DEVIATION REQUEST AND DECISION FORM

Project Name :	Skyline at Lorson Ranch
Schedule No.(s) :	5500000440, 5500000274, 5500000275, 5513300005, 5513310105
Legal Description :	See Attached

A deviation from the standards of or in Section 2.5.2.(C2) of the Engineering Criteria Manual (ECM) is requested.

DEVIATION 2
EXHIBIT

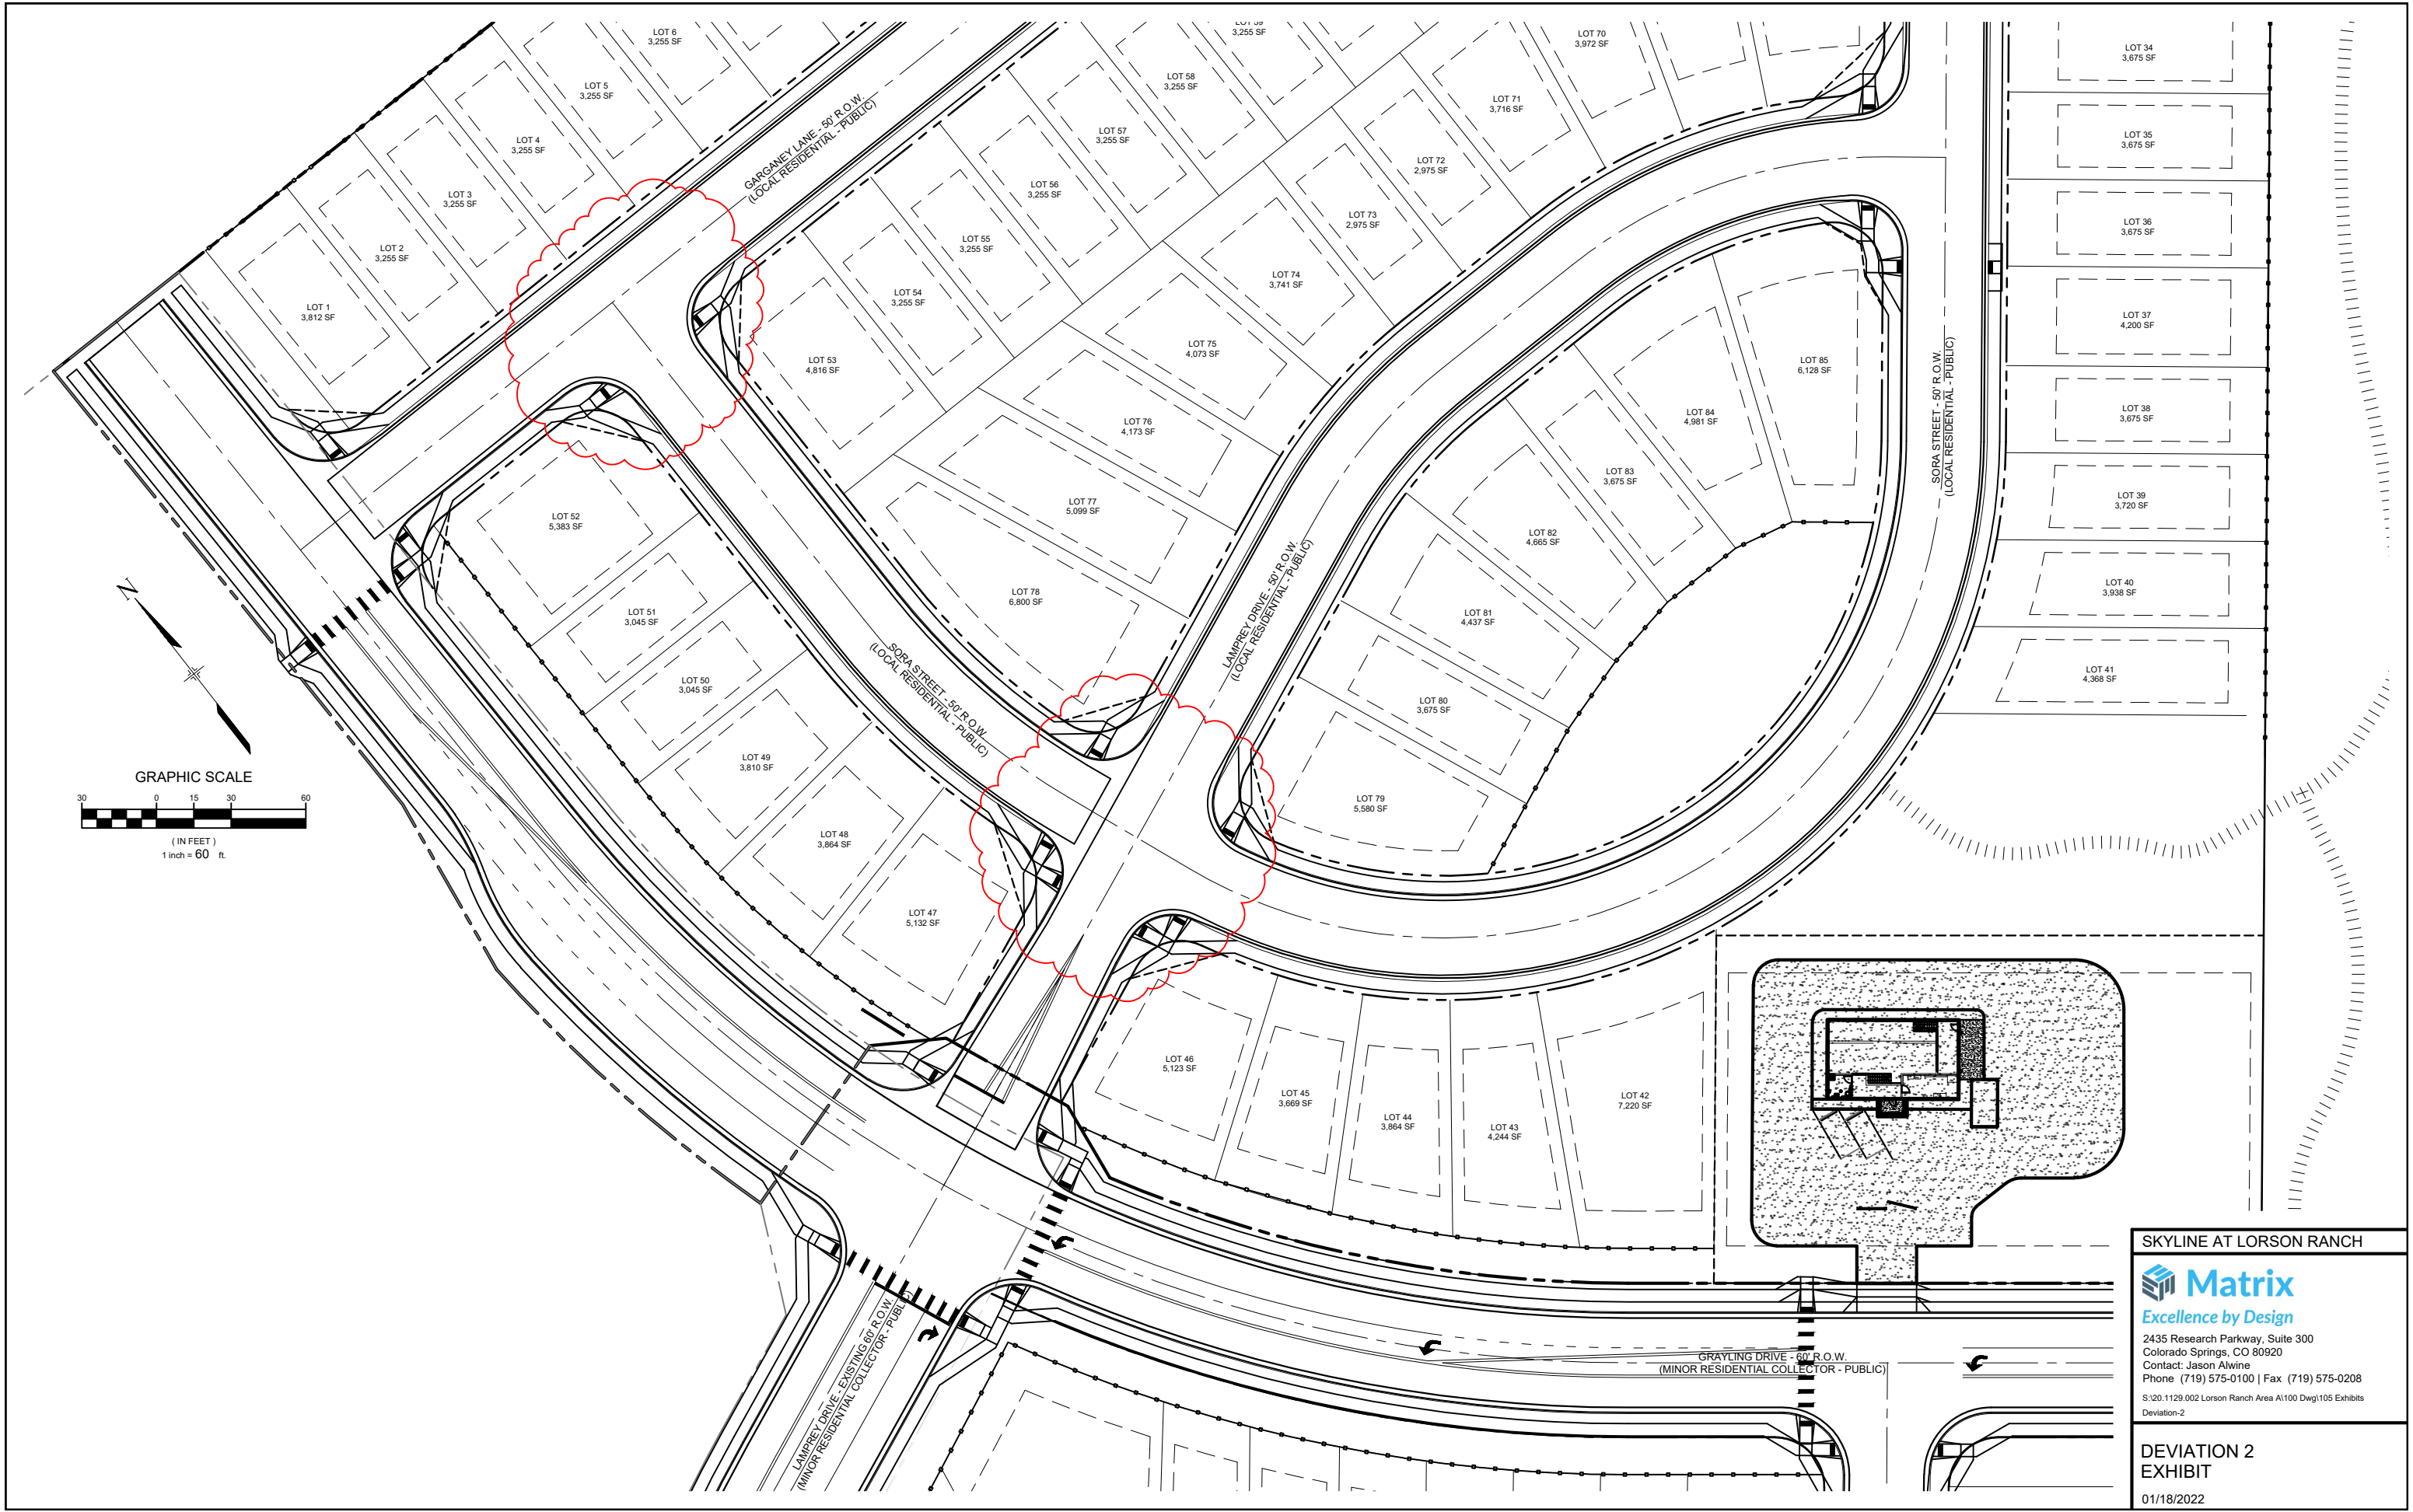
Allow only two pedestrian ramps to be constructed at the T-intersection of Garganey Lane and Sora Street and allow only six pedestrian ramps to be constructed at Sora Street and Lamprey Drive.

Both the intersections are in proximity of another intersection with all ramps installed as required. Installation of all corner ramps at these two intersections is not feasible as the grading cannot meet ADA requirements along the ADA curb returns. However, the intersections are providing multiple access points and does not limit pedestrian movements.

Elimination of ramps at each of the intersections will not impede pedestrian movements and will result in safer pedestrian crossing due to grading concerns and inability to meet ADA slope requirements (where required). A pedestrian will be able to cross at alternate locations within approximately 85' or less of the eliminated ramps.

This request has been determined to have met the criteria for approval. A deviation from Section 2.5.2.(C2) of the ECM is hereby granted based on the justification provided.
